511 Capitol Building Stabilization Project IOWA CITY, IOWA 10271-10004

ADDENDUM 02

December 2, 2025

This addendum forms a part of the Contract Documents and modifies the original bidding documents dated November 14, 2025, as noted below.

A501

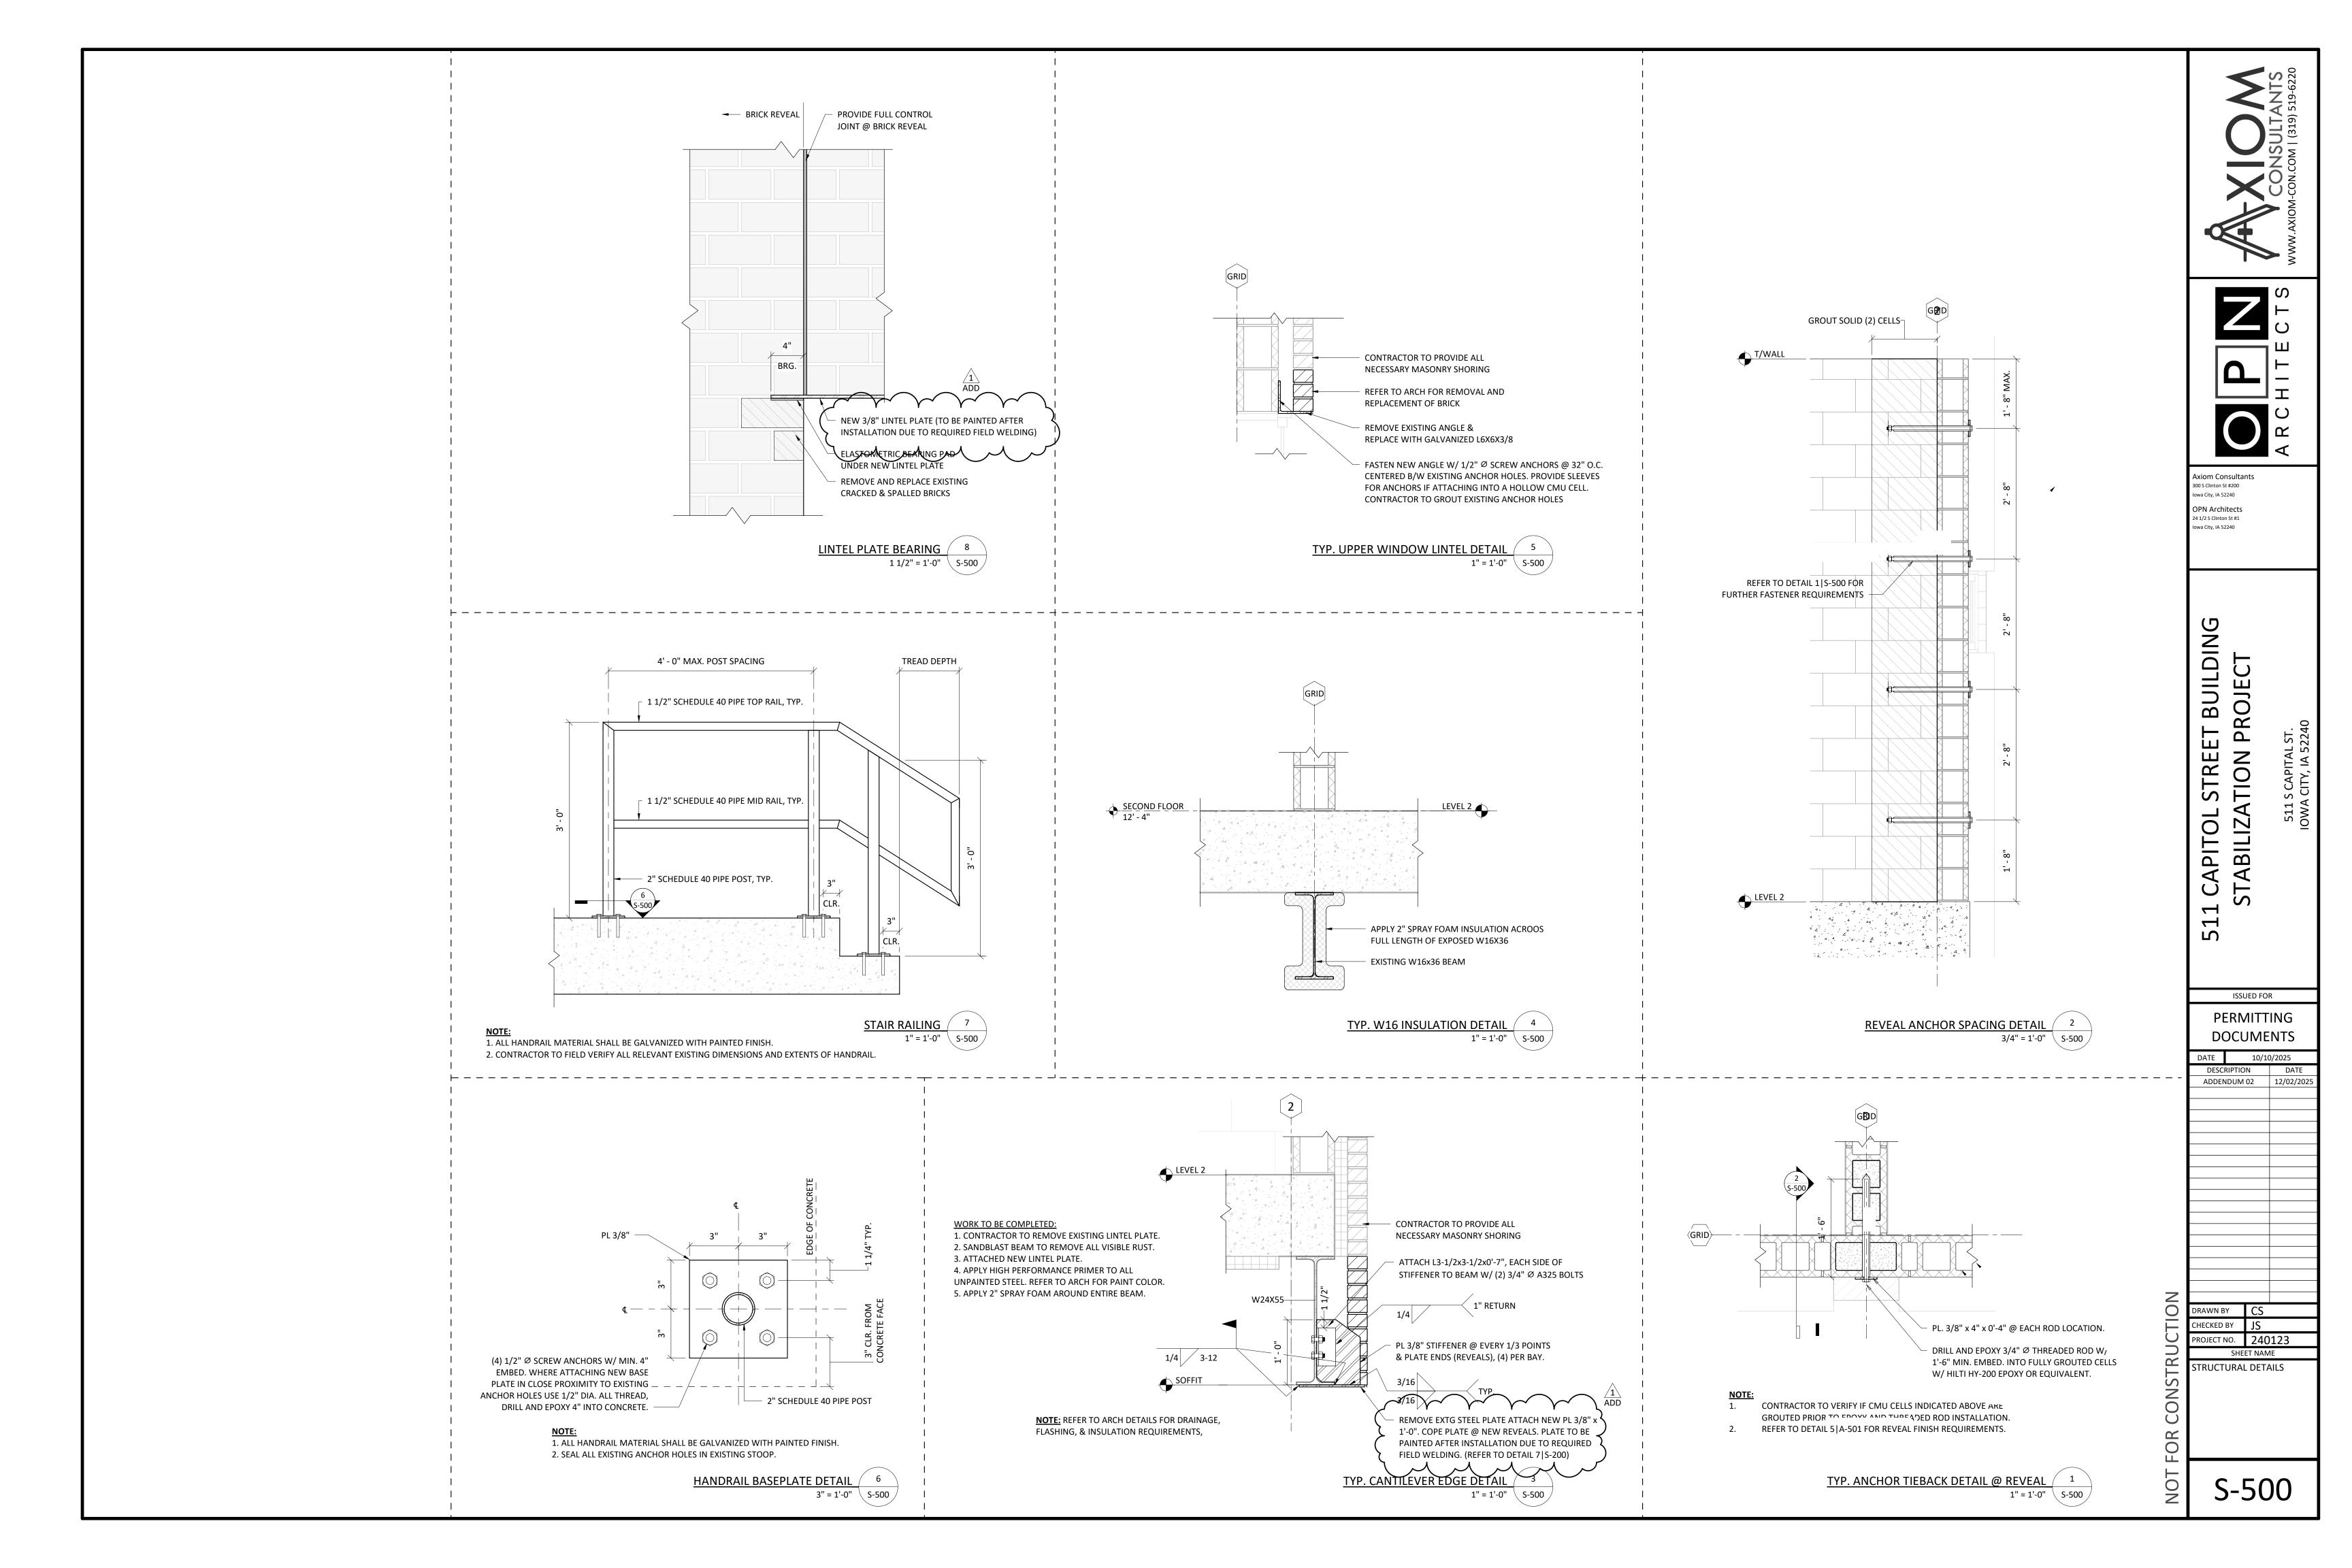
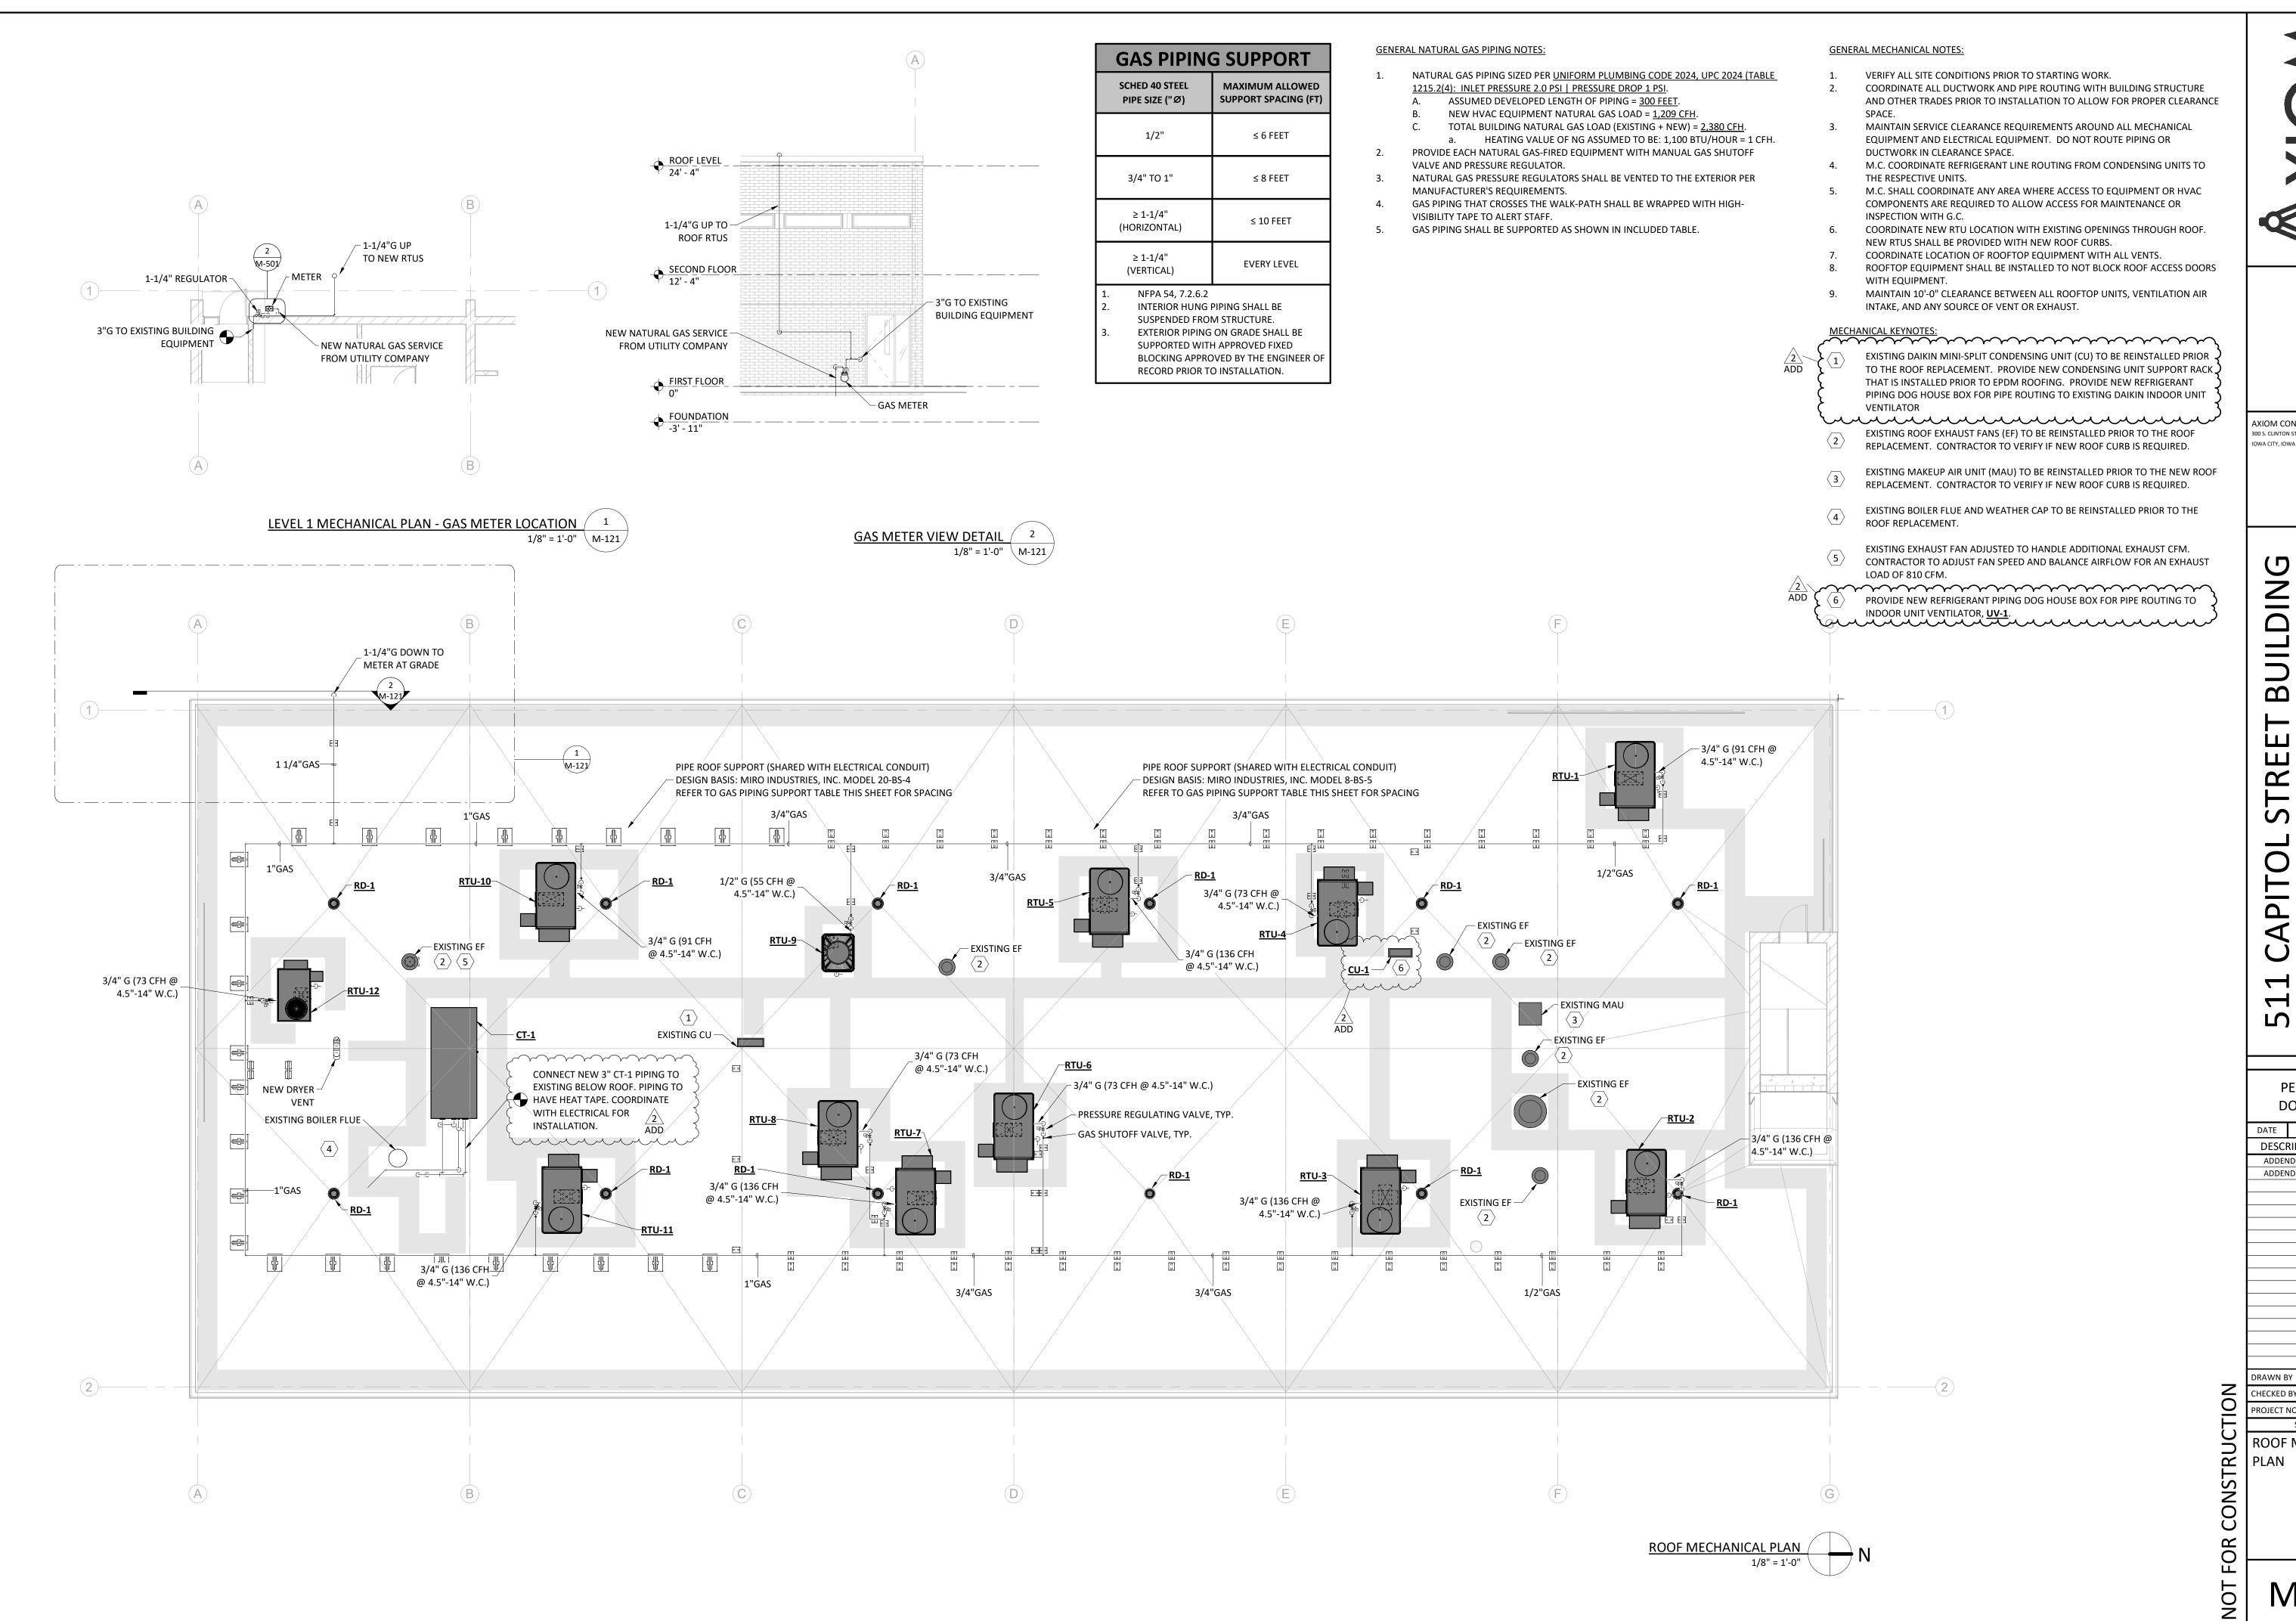
1. REVISED notes on detail 3 to clarify sill replacement scope.

SCHEDULES

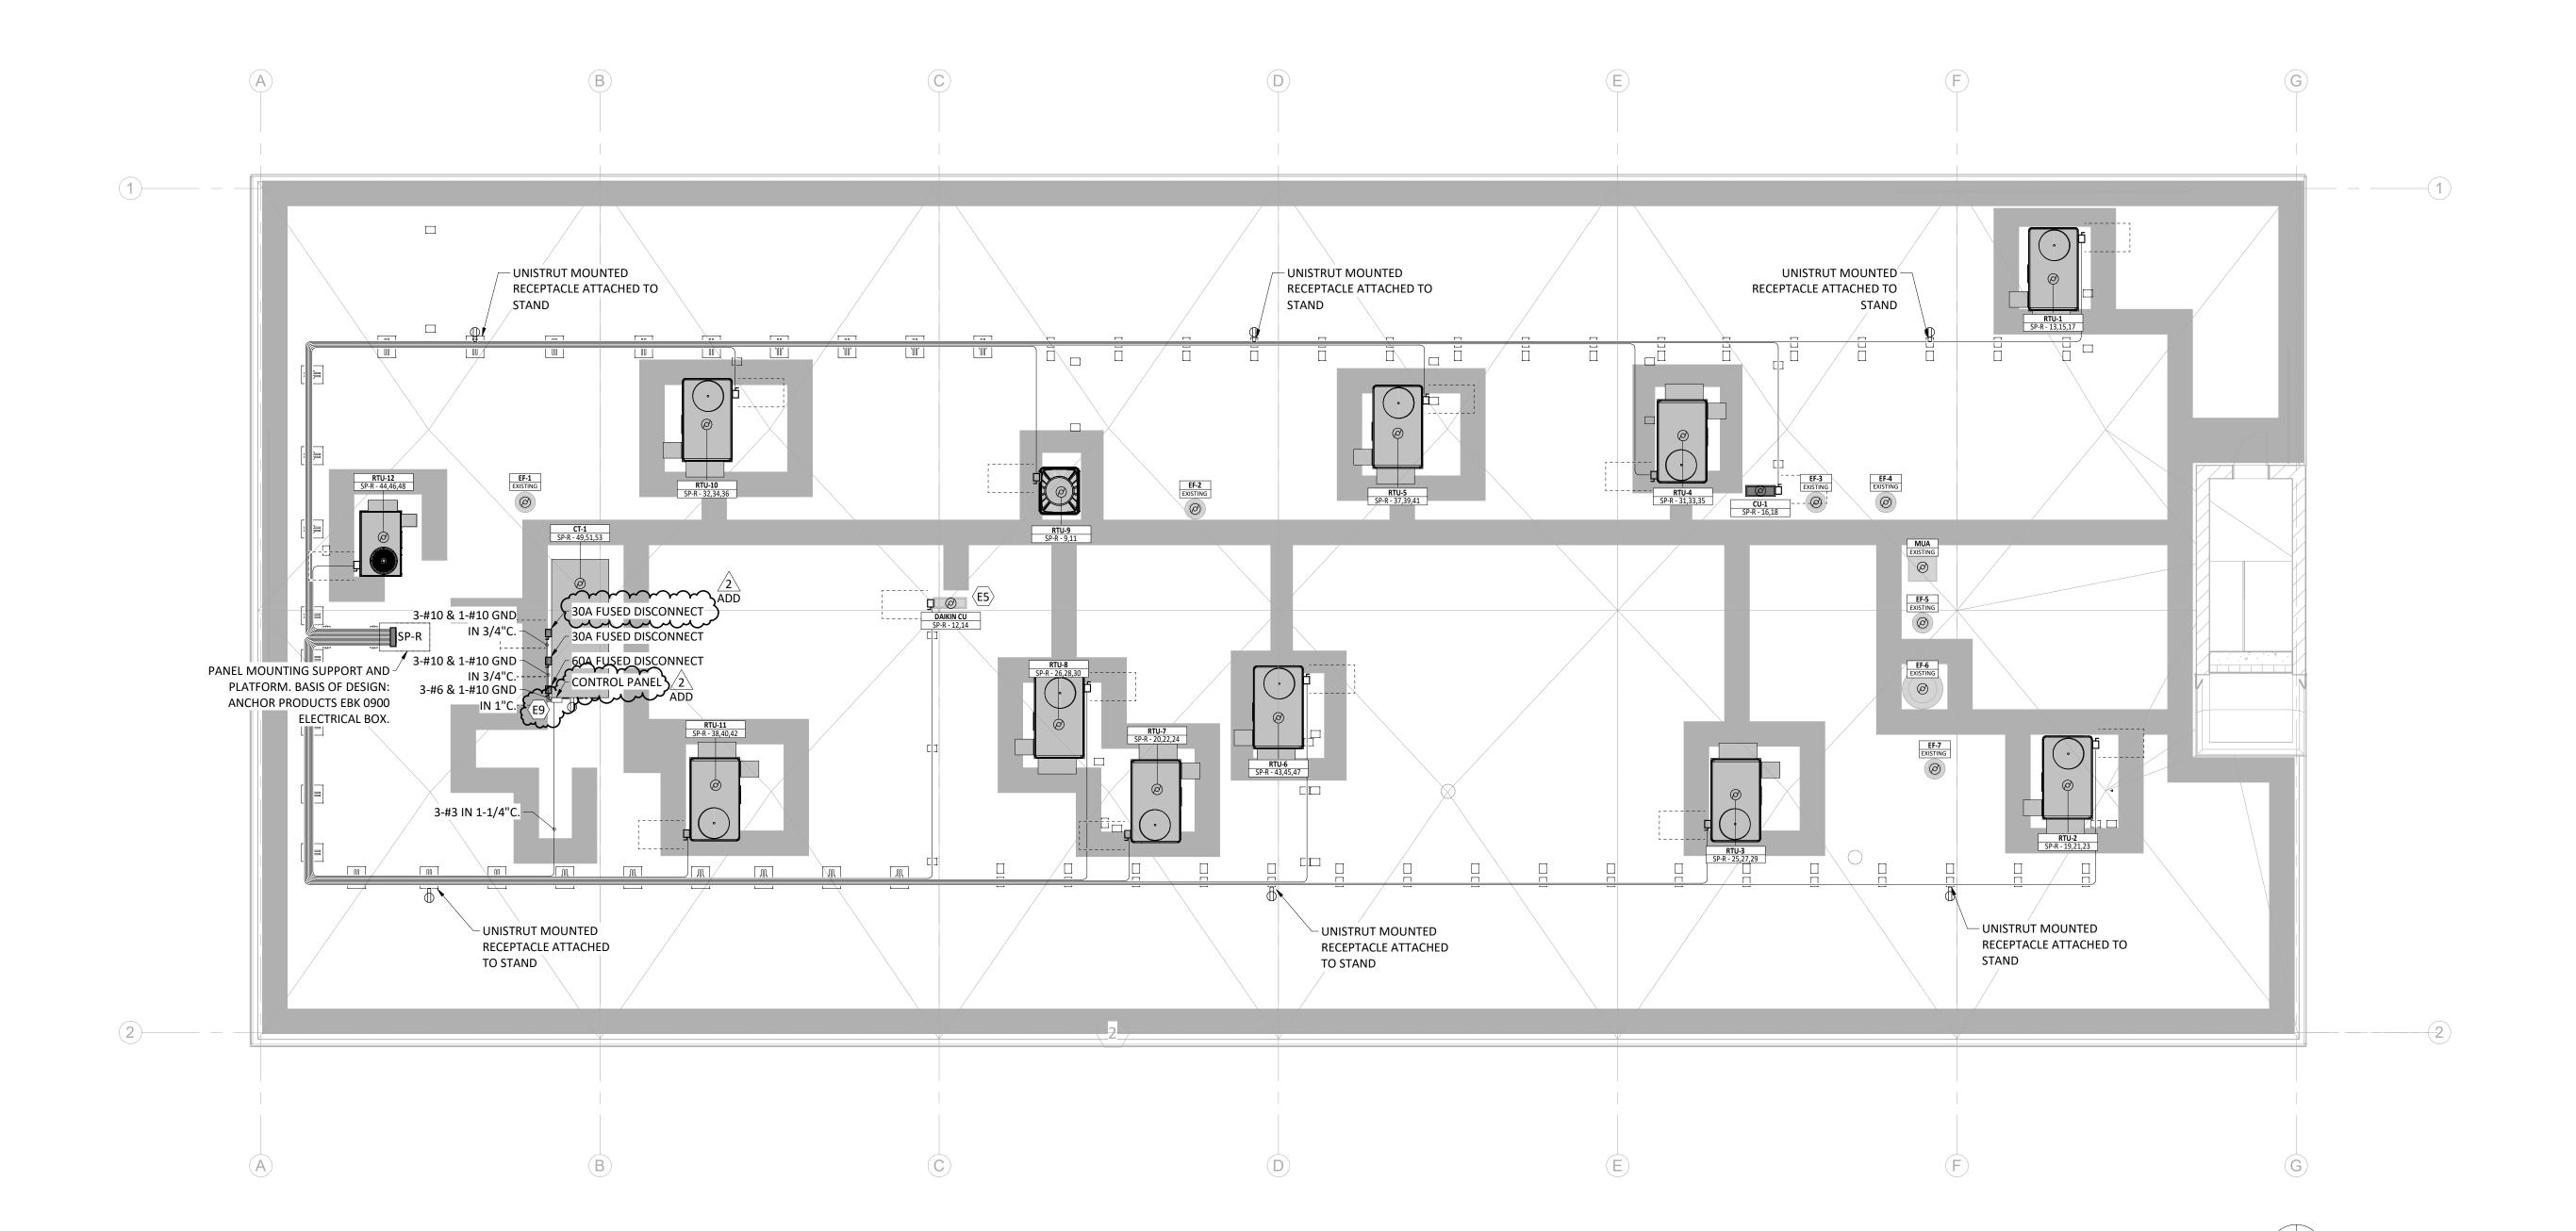
- 1. ADDED Pipe connection size to roof drain, RD-1.
- 2. ADDED Refrigerant pipe dog house note to MINI-SPLIT AIR-CONDITIONER SCHEDULE.

3. ADDED Cooling tower alarm controls note to be provided by owner on CLOSE CIRCUIT COOLER SCHEDULE.
